**SUBMISSIONS RECEIVED DURING
EXHIBITION OF DRAFT VOLUNTARY
PLANNING AGREEMENT**

1 ALFRED STREET, SYDNEY

RE: Draft Planning Agreement - 1 Alfred St, Circular Quay Sydney between The Council of the City of Sydney and Valad Commercial Management Limited

SK 01
APRIL 12

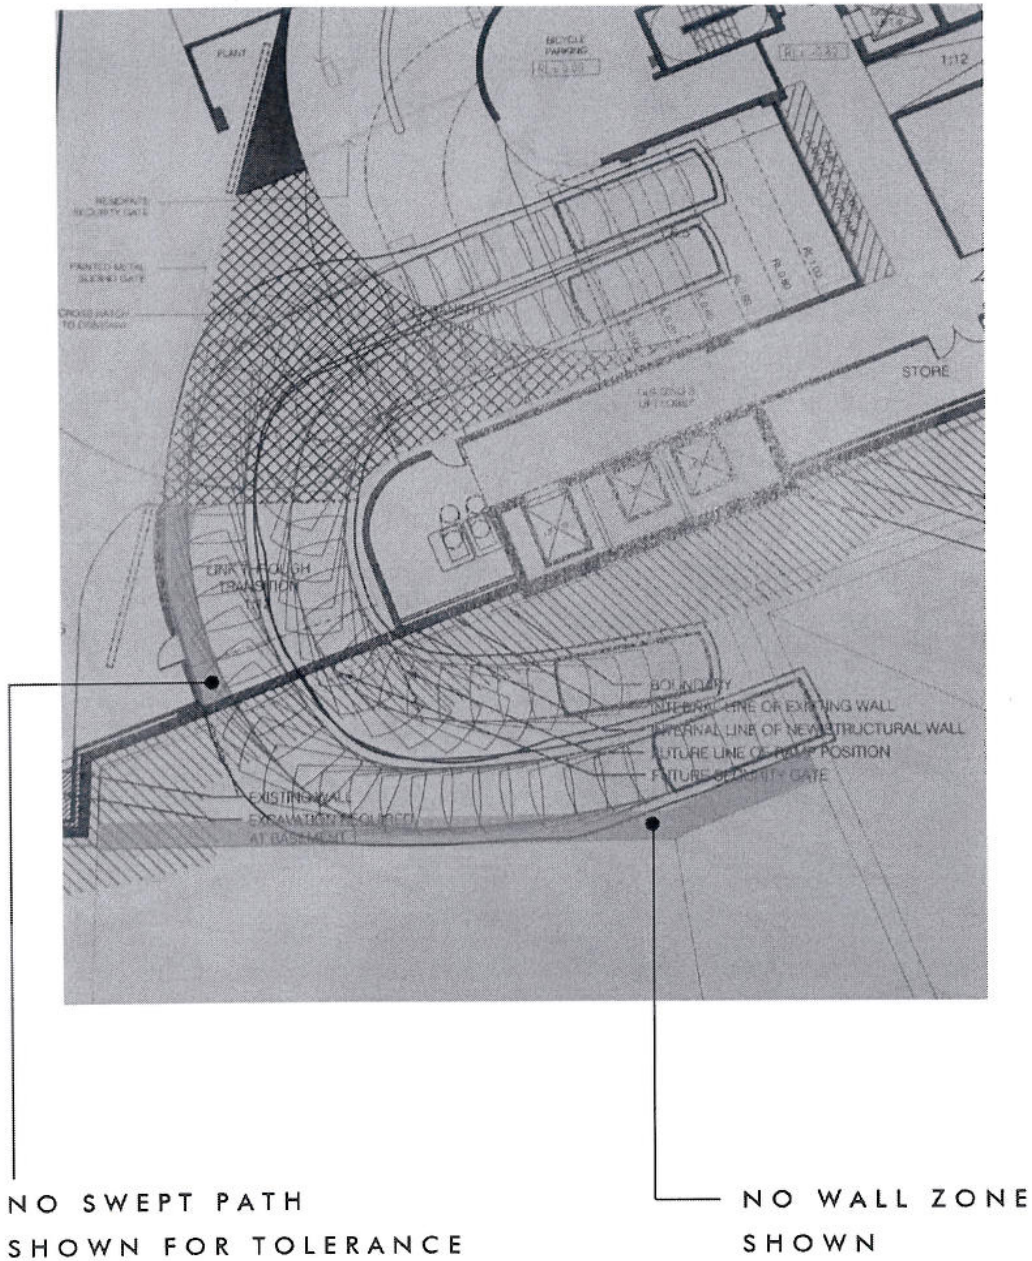
SK01 shows the analysis presented by the applicant in support of the carriageway design and appears to show 2 car lane access. Two shortcomings in the analysis have been highlighted.

- no allowance has been made for a wall zone along the boundary of the 'tail' of the 19-31 Pitt st site, leading to an unrealistic and naïve presentation of potential access for cars via the carriageway.

- The sweep paths shown indicate non-compliances with the design at several points.

SK 02
24 April 2012

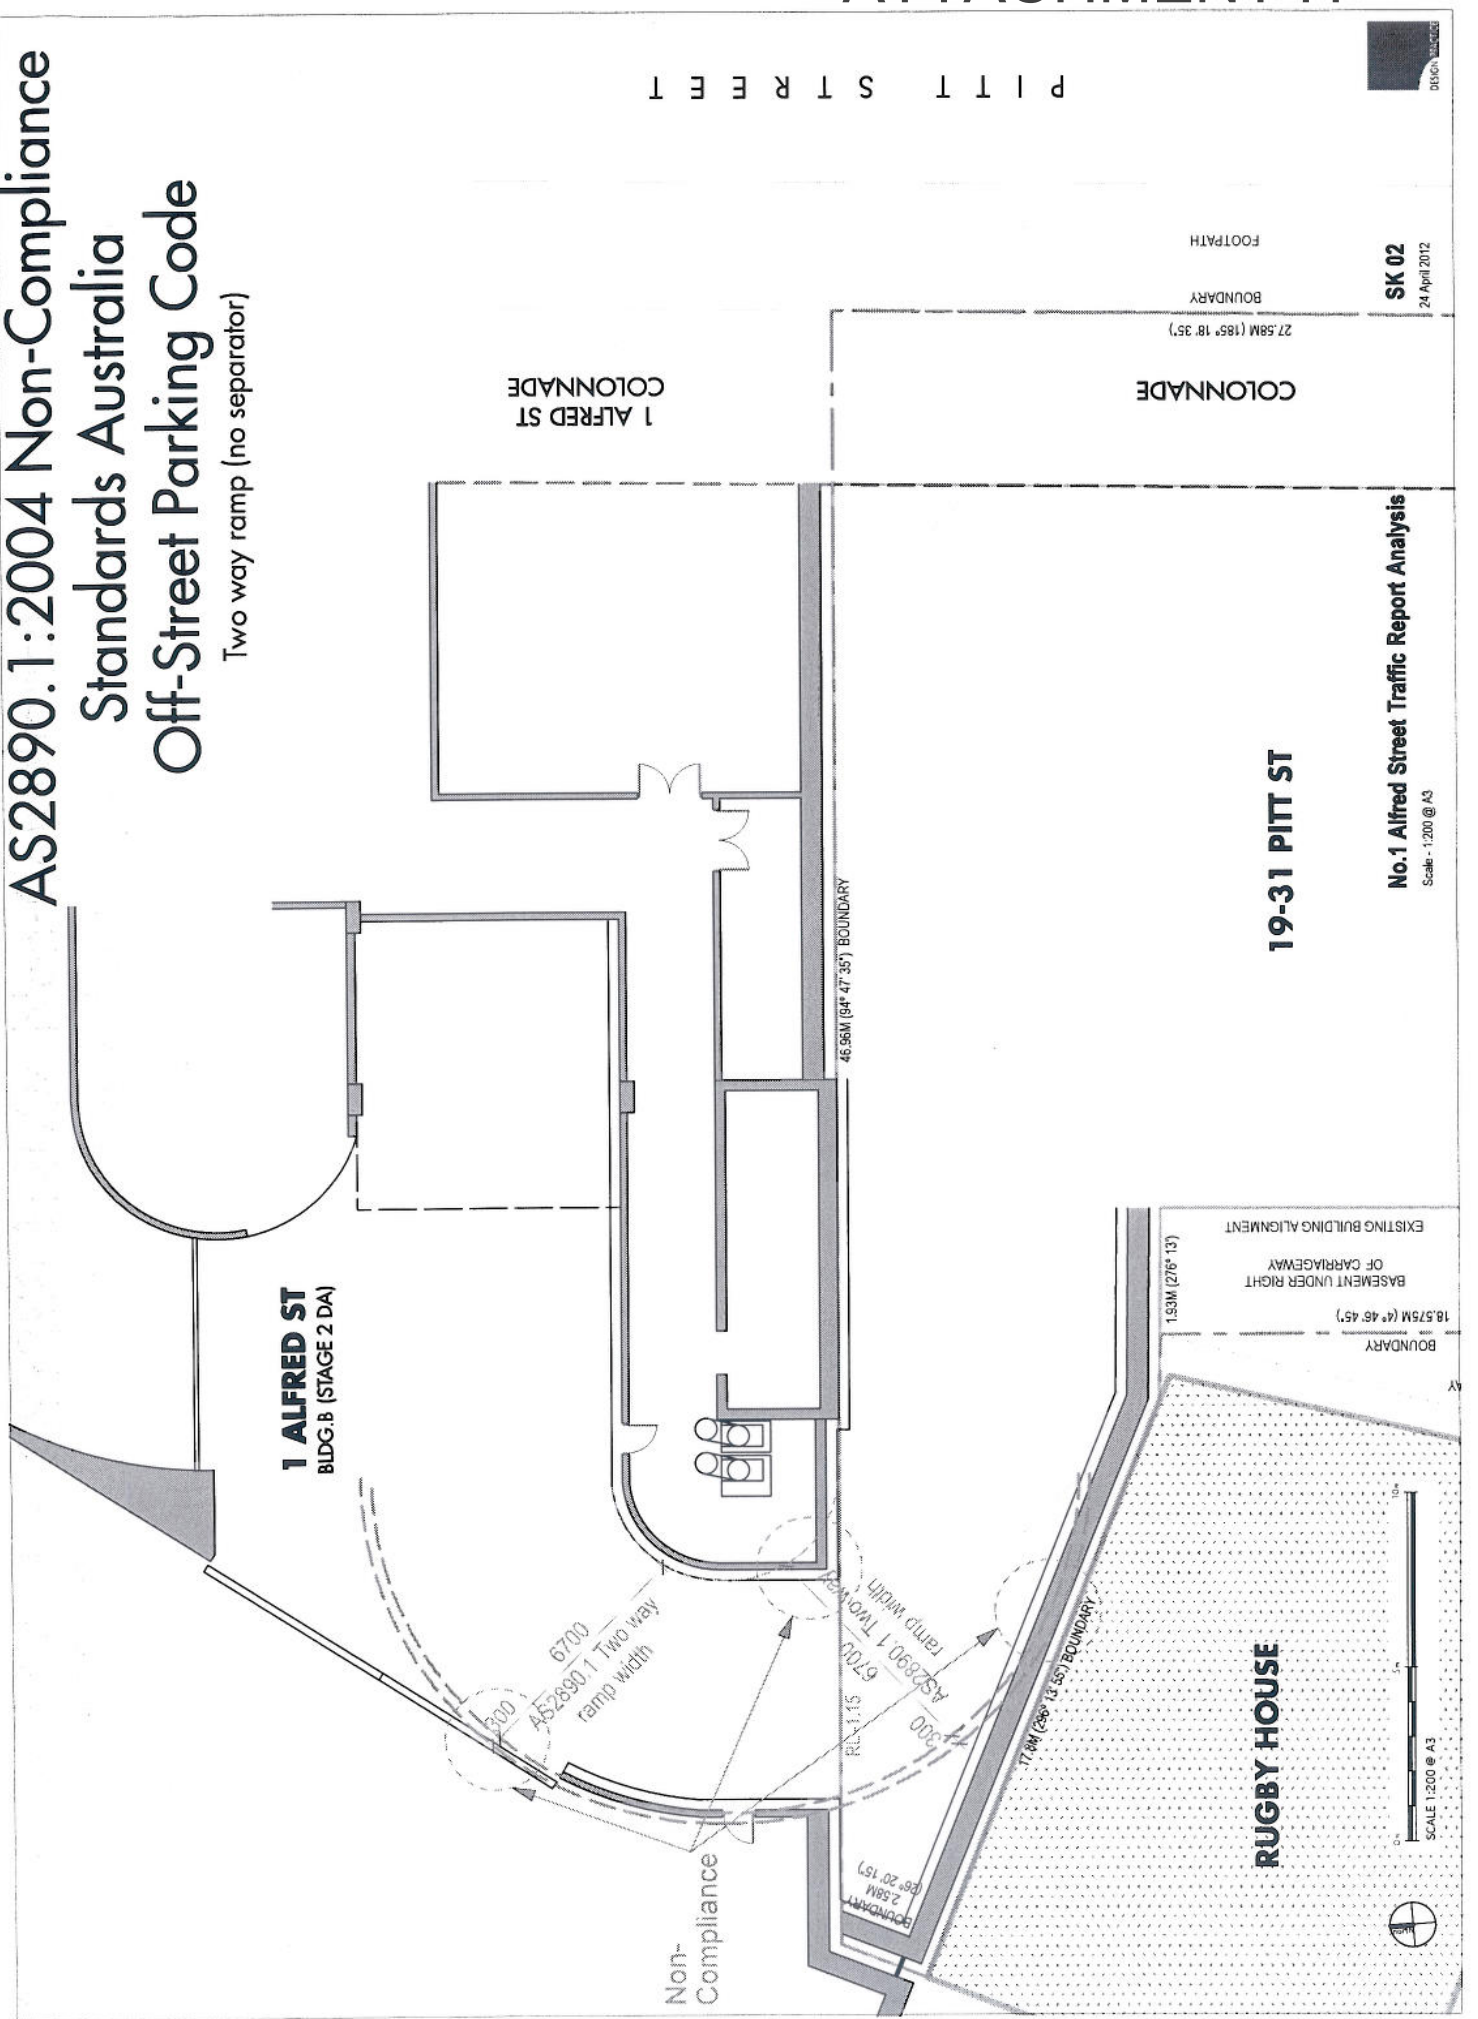
SK02 shows the Australian standard for the off street parking code applied to the applicants proposal and identifies at least 3 areas where the carriageway proposed would not accommodate compliant access.

AS2890.1:2004 Non-Compliance Standards Australia Off-Street Parking Code

SK 04
APRIL 12

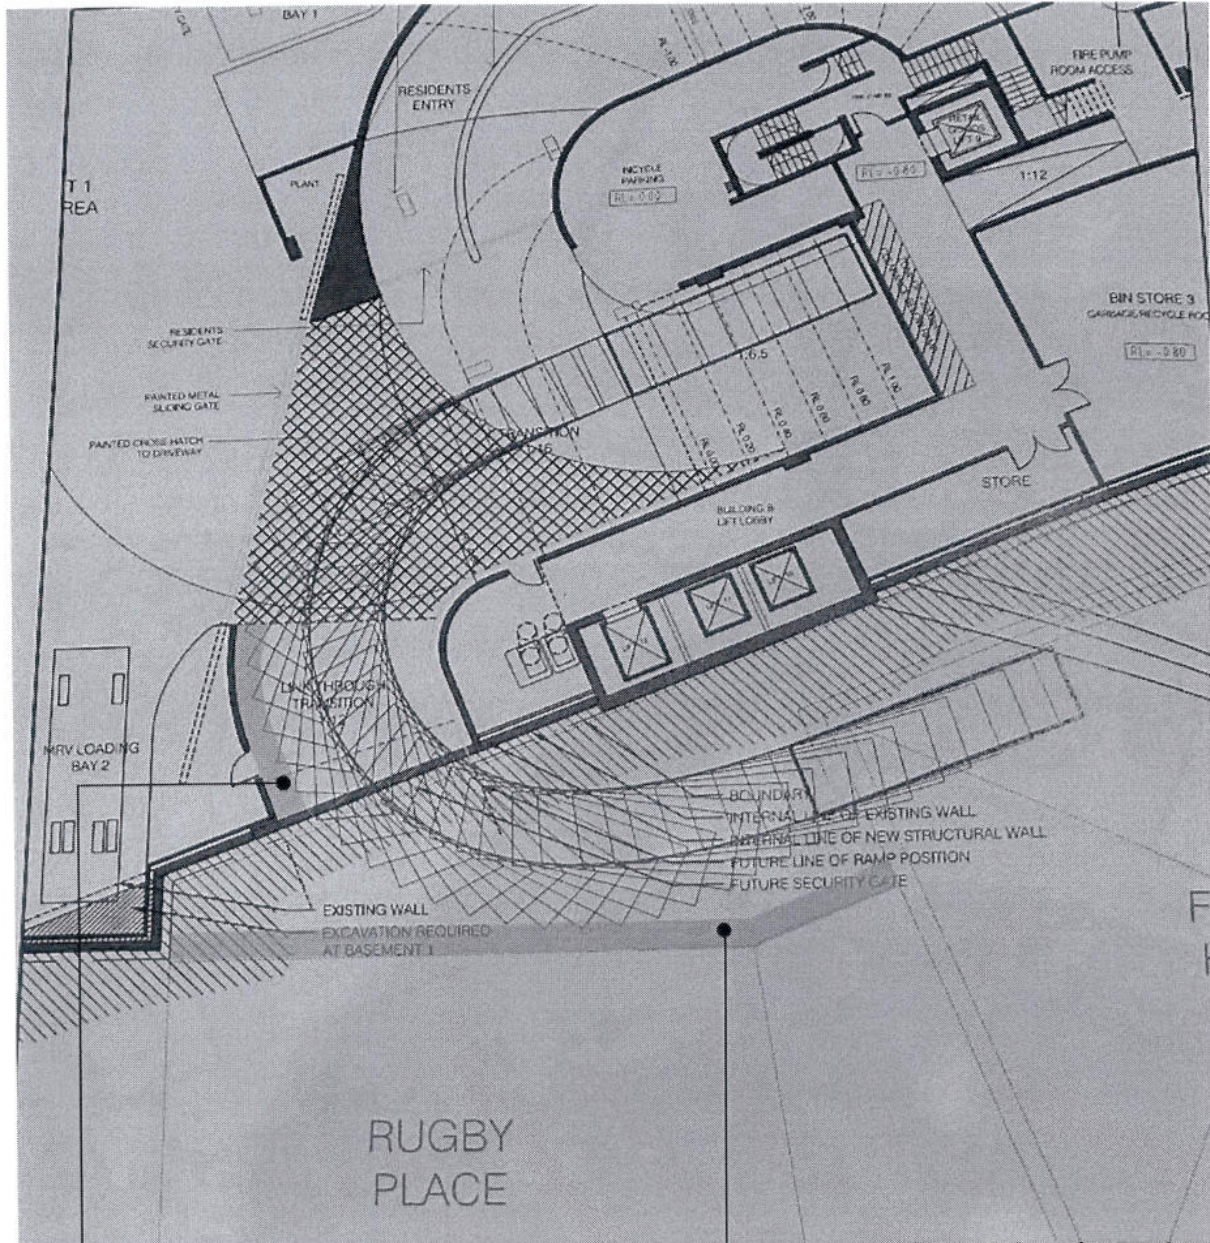
SK04 and SK05 shows the analysis presented by the applicant in support of the carriageway design and appears to show compliant access for 8.8m rigid and 10.2 refuse vehicles. Shortcomings in the analysis have been highlighted.

- no allowance has been made for a wall zone along the boundary of the 'tail' of the 19-31 Pitt st site, leading to an unrealistic and naïve presentation of potential access for larger vehicles via the carriageway.

- The sweep paths shown indicate non-compliances with the design at several points..

- It is also noted it seems unclear what standard was applied in the analysis.

NO SWEEP PATH
SHOWN FOR TOLERANCE

NO WALL ZONE
SHOWN

SK 05
APRIL 12

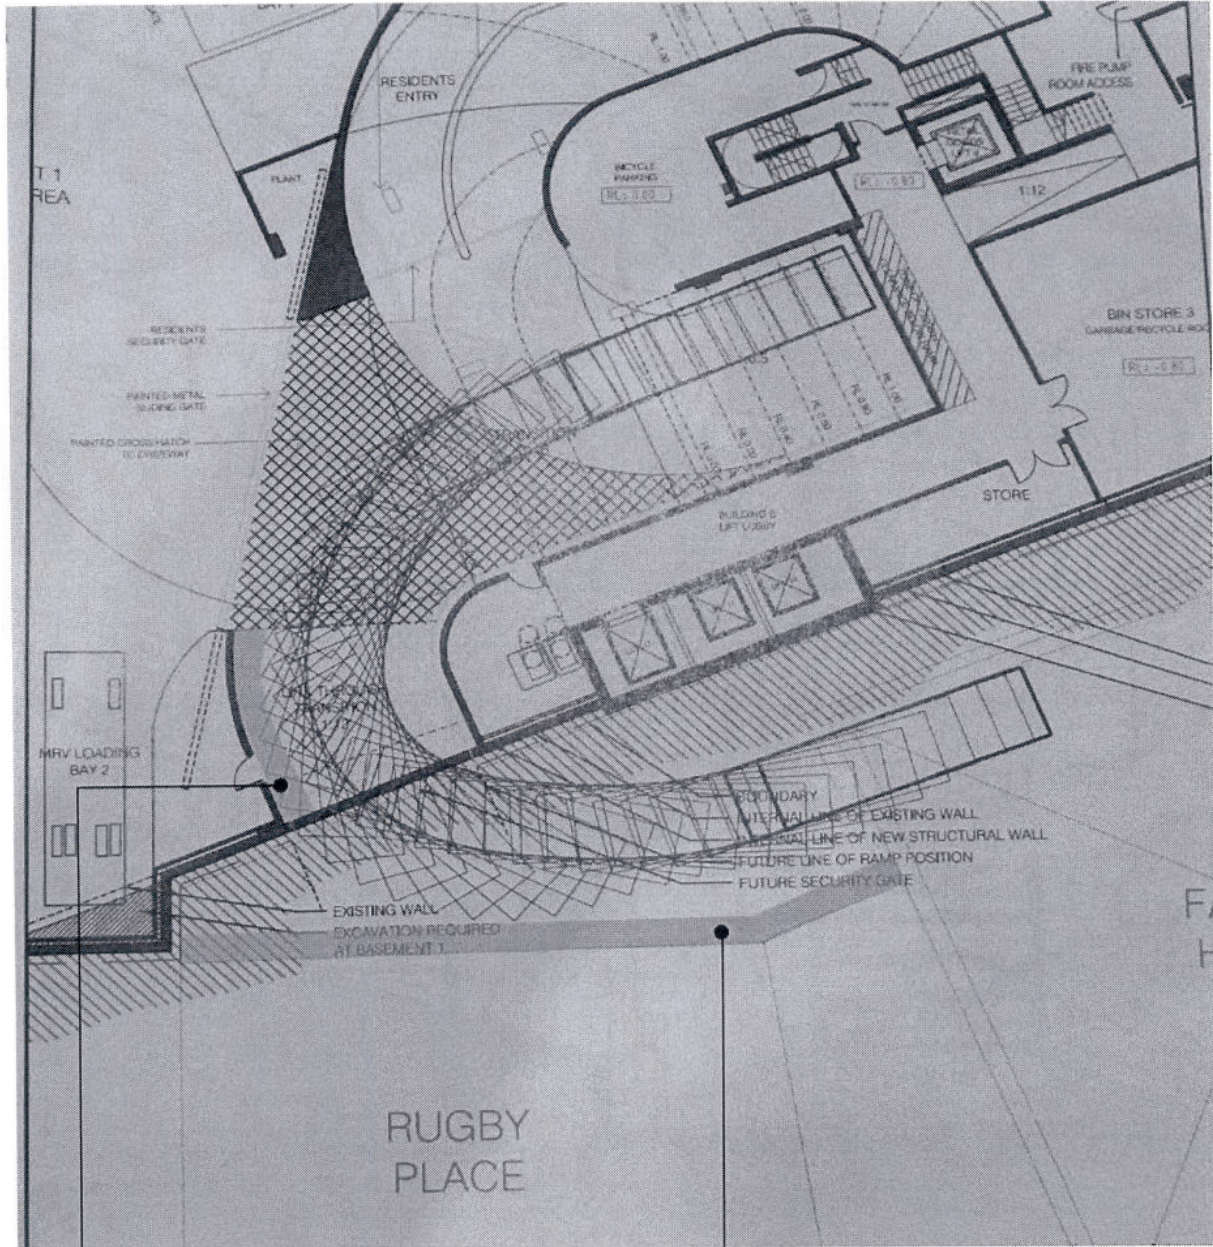
NO SWEEP PATH
SHOWN FOR TOLERANCE

NO WALL ZONE
SHOWN

SK 06
24 April 2012

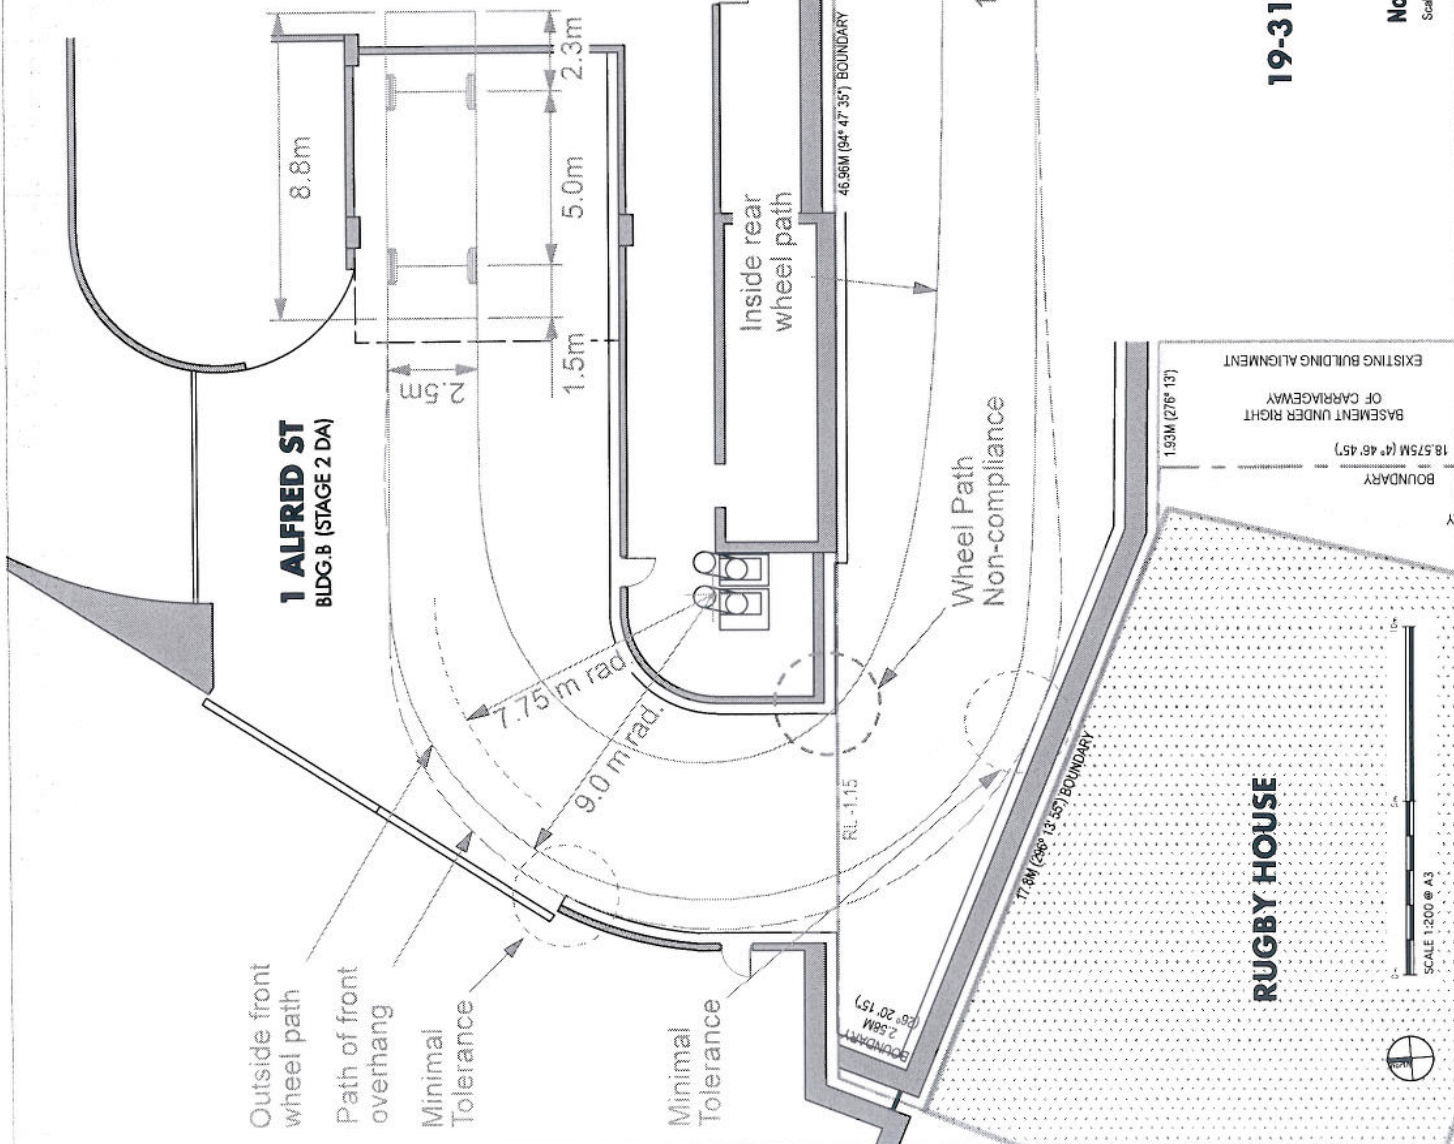
SK06 and SK07 show the Austroads turning path templates for an 8.8m & 12.5m vehicle respectively. The turning circles for both trucks indicate 3 areas of non-compliance in the proposed carriage way design which will prevent complaint and safe use of the carriage way by larger vehicles.

8.8m Truck Turning Circle Non-Compliance

SK 07
24 April 2012

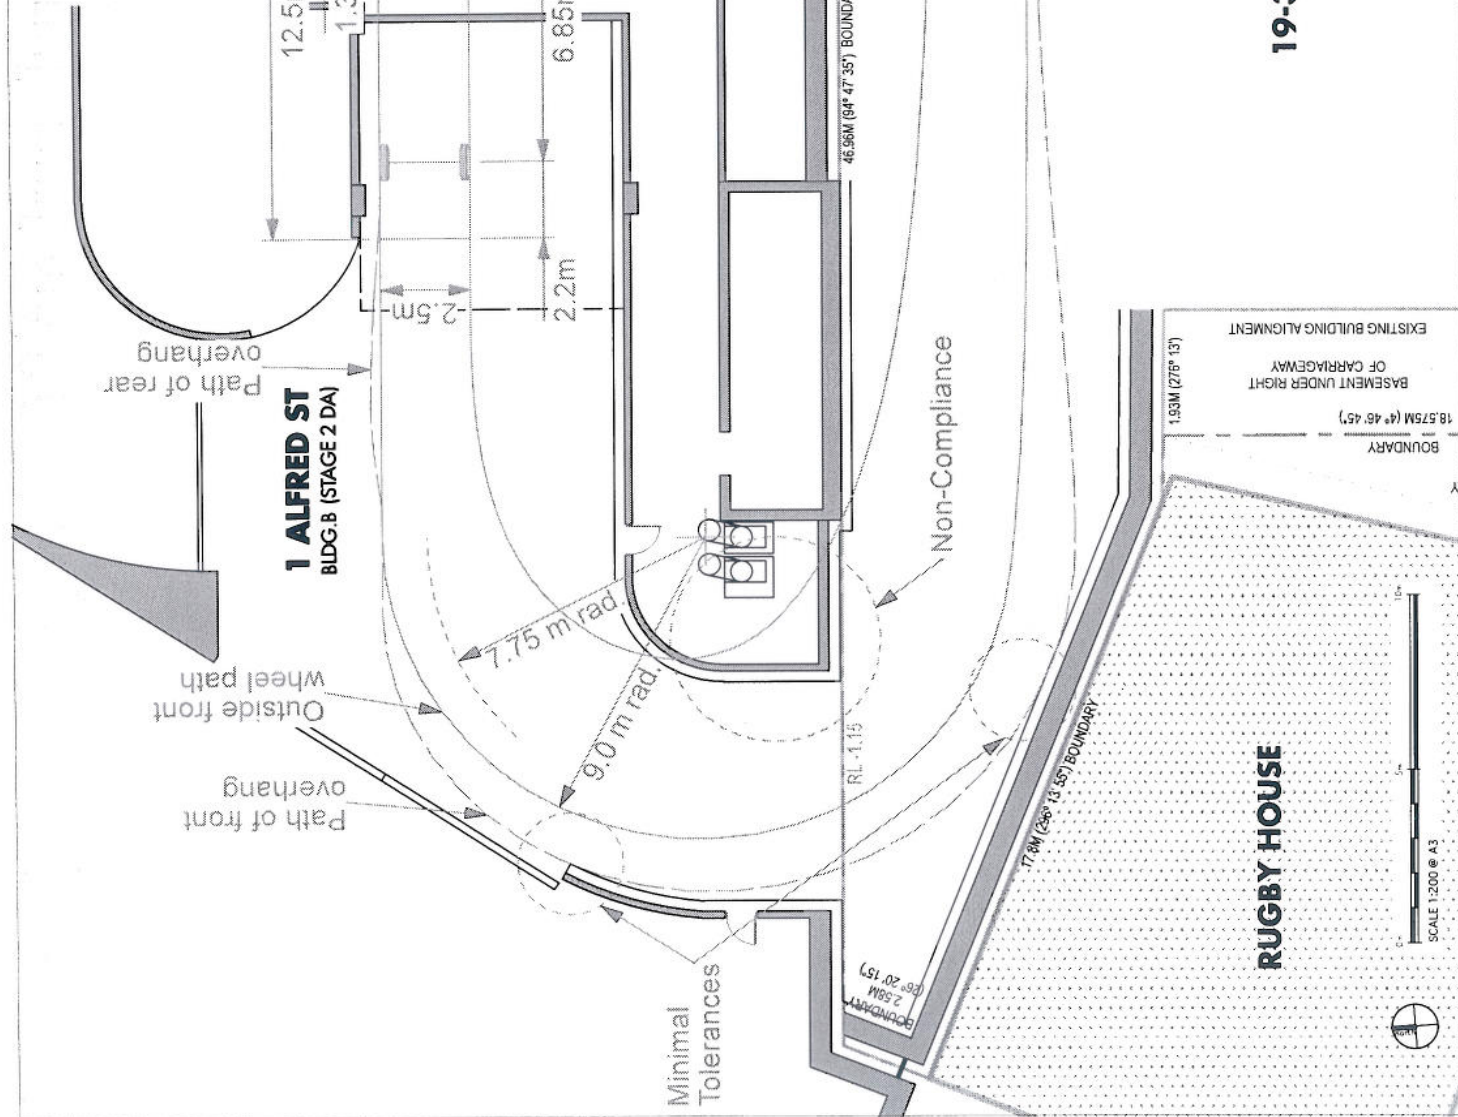
12.5m Truck Turning Circle Non-Compliance
